Three Mile Island Nuclear Station Unit 2 (TMI-2)
Operating License No. DPR-73
Docket No. 50-320
TMI-2 Additional Information of Cork Seam

RESPONSE TO REQUEST FOR ADDITIONAL INFORMATION ON TMI-2 CORK SEAM CONTAMINATION

TABLE 1

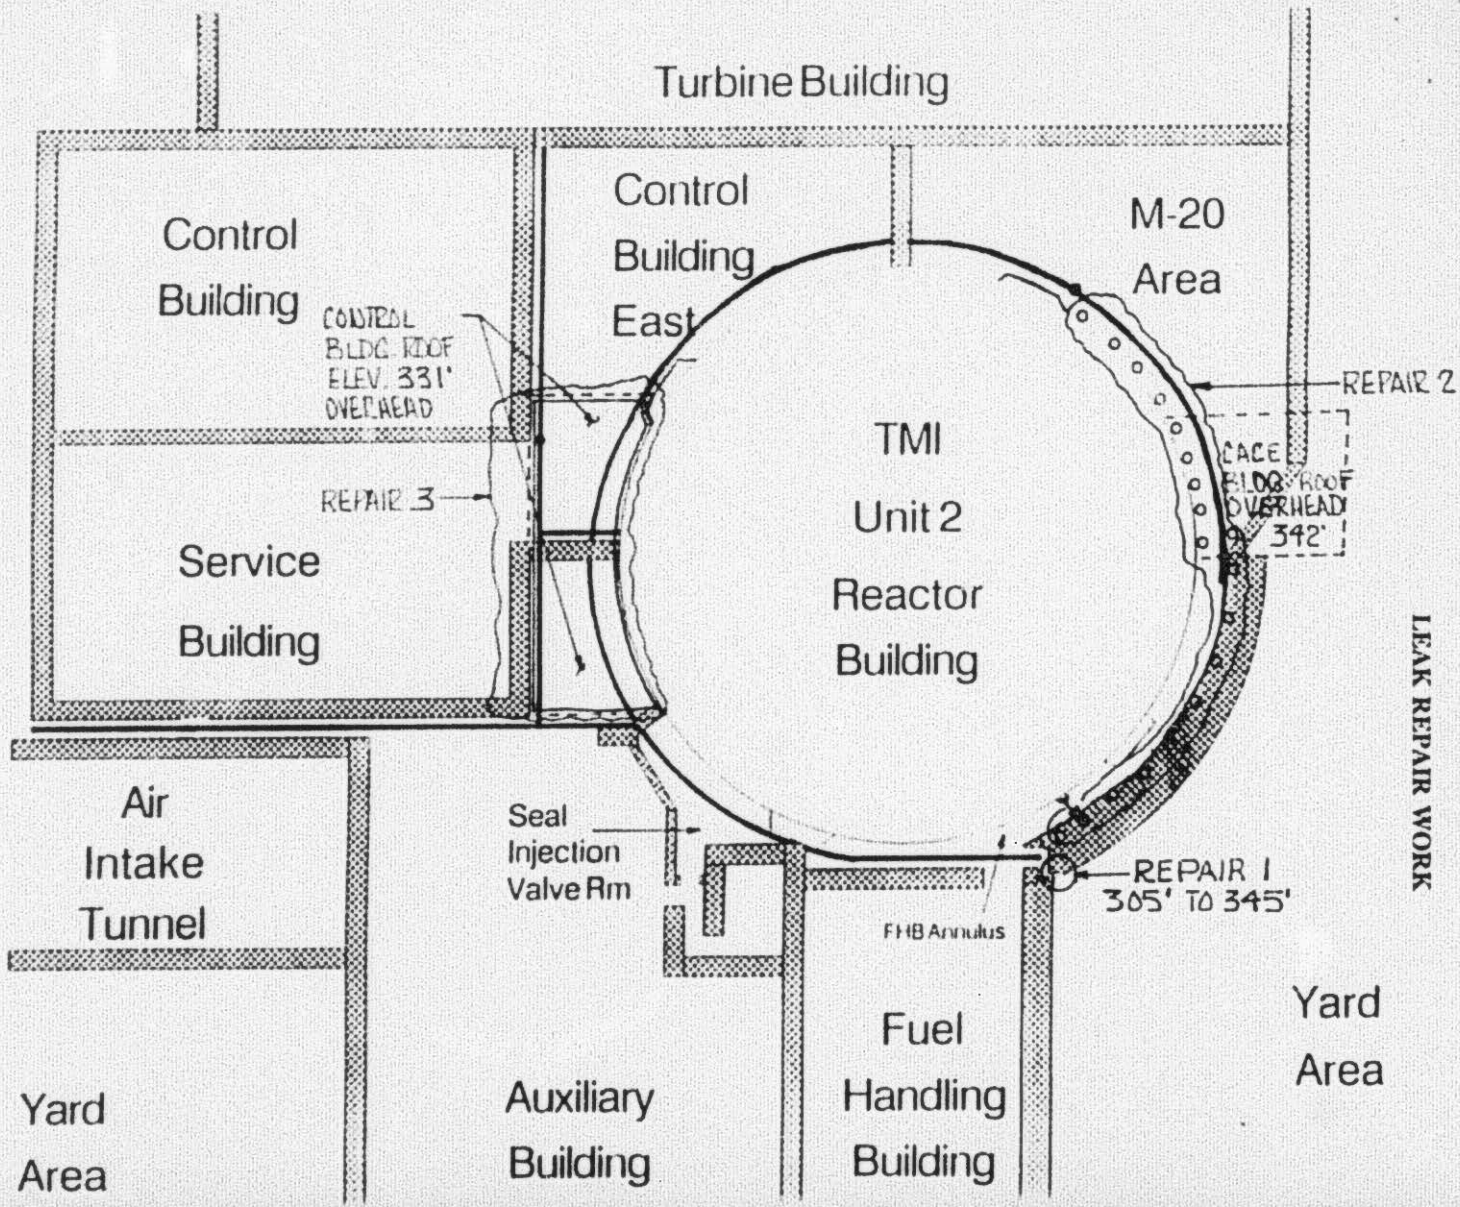
3. Provide an estimate of the amount of water and radioactive contamination in the cork seam.

RESPONSE: The cork seam is one to two inches wide, approximately 600 feet in linear length, and filled with cork to a depth of three to five feet, depending on location. It was originally estimated that there could be a maximum of 1000 gallons of contaminated water in the seam. However, the pumping experience of December 3 and 6, 1993 indicates that there is much less than 1000 gallons of contaminated water in the cork seam. The activity level of a water sample taken from a one-inch diameter core-bored

hole in the Auxiliary Building is listed in Table 1. This hole is located five feet from the Seal Injection Valve Room (SIVR). A water sample extracted from a one-inch diameter core-bored hole in the M-20 area shows no contamination in that area. It is estimated that there is an additional 200 gallons of non-contaminated (i.e., "clean") water in the M-20 area cork seam.

Therefore, based on samples taken over the course of the cleanup including the water sample noted above, the estimate of the total contamination in the seam outside the SIVR is 5 Ci of Cs-137 and 1 Ci of Sr/Y-90. Using these values as a basis, the estimate of the contamination in the cork seam in the SIVR is 15 Ci of Cs-137 and 4 Ci of Sr/Y-90.

FIGURE 2

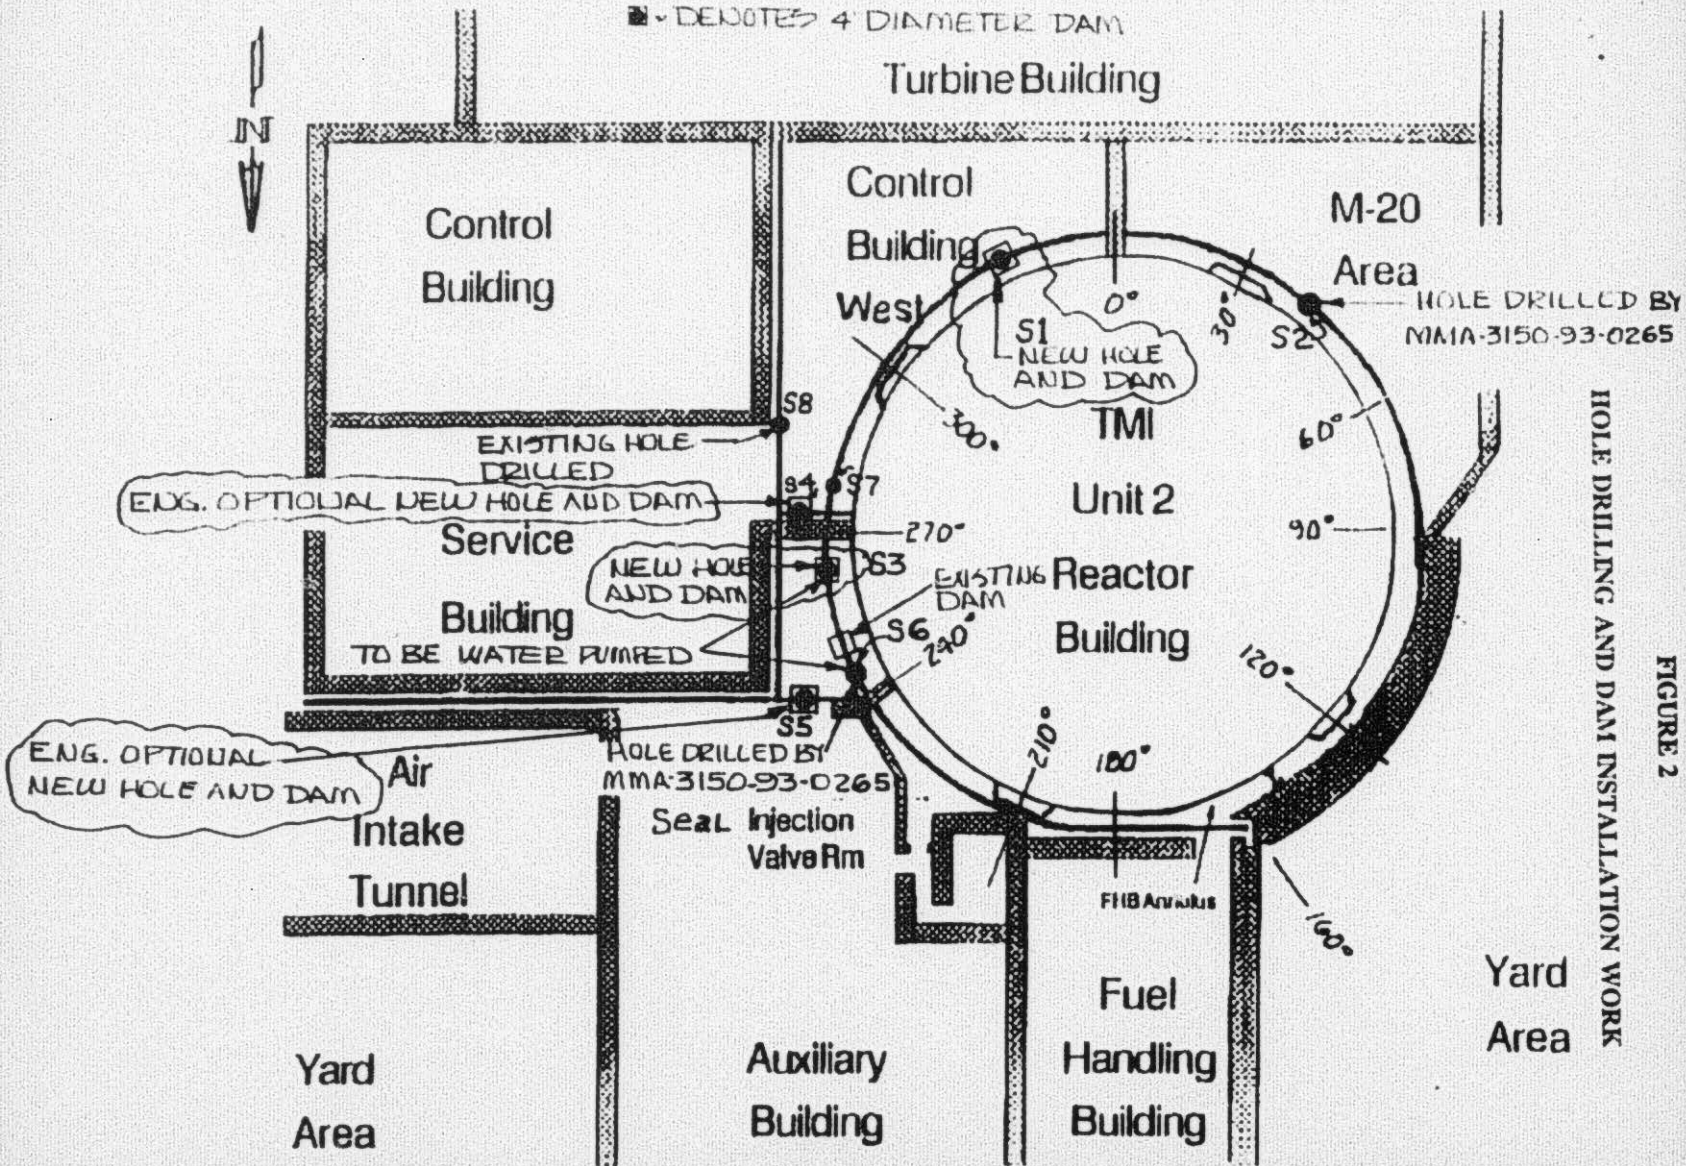
5. Describe your monitoring program to monitor water level and contamination containment in the cork seam once the facility enters PDMS.

RESPONSE: During the removal of water from the cork seam, four four-inch diameter dams will be installed to prevent contamination from spreading and to provide monitoring locations, and two additional one-inch diameter holes (2 currently exist) will be drilled for pumping (See Figure 2). The dams will be made from an injectable polyurethane grout. This material adheres to wet surfaces and expands to form a closed cell foam that will fill any gaps in the concrete adjacent to the cork seam. In addition, after the dams and pumping/monitoring holes are installed and the water is removed, GPU Nuclear will evaluate whether additional actions are required, i.e., removal of cork material or capping of the cork seam.

After the water removal process has been completed, a liquid level monitoring device will be inserted in each of the four sections in the one-inch diameter holes. At least monthly, for a period of one year, these holes will be monitored for water entering the seam. The monitoring program will be reevaluated after the initial one year period.
